# City of Mississauga Department Comments

File(s): A366.23 Ward: 7

Property Address: 508 Cullen Ave

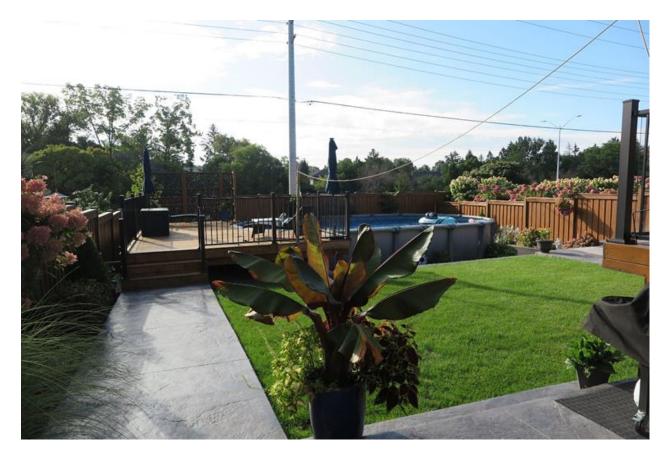
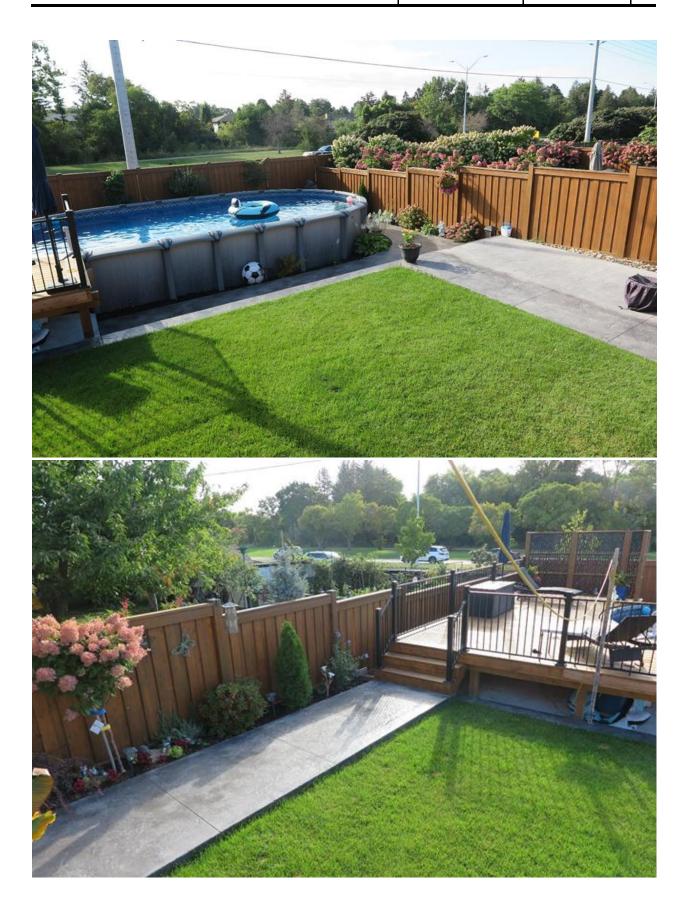
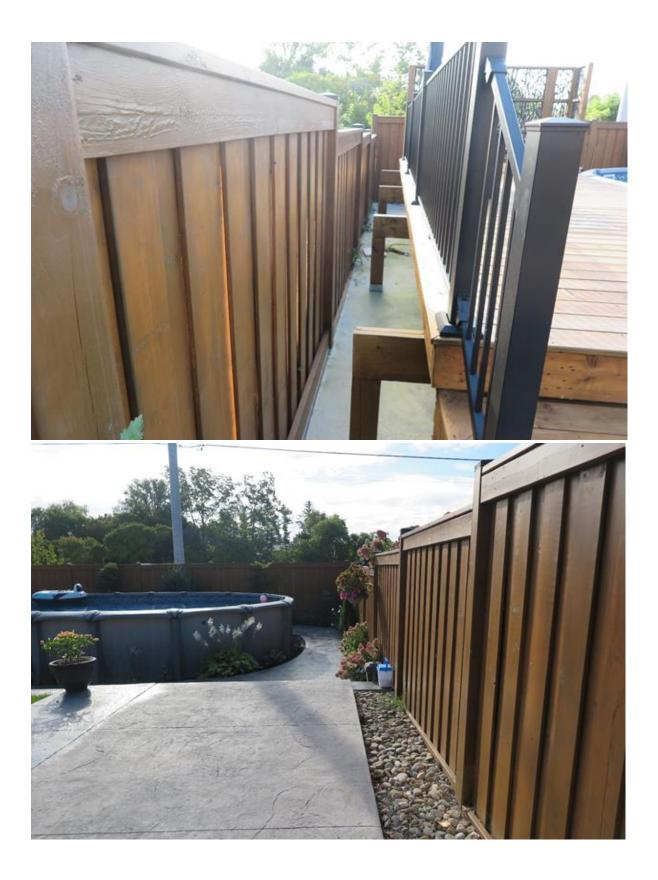
From our site inspection of the property and the attached photos it is evident that this property has front to rear drainage pattern which means that drainage is directed towards the rear of the property. We note that to the rear of the backyard is Queensway West and that the abutting residential properties have the same drainage pattern. For Variance 1 to 4 we have no drainage related concerns. For Variance 5 & 6 pertaining to the driveway width, we have no objections to the requested driveway width as depicted on the Site Plan submitted.
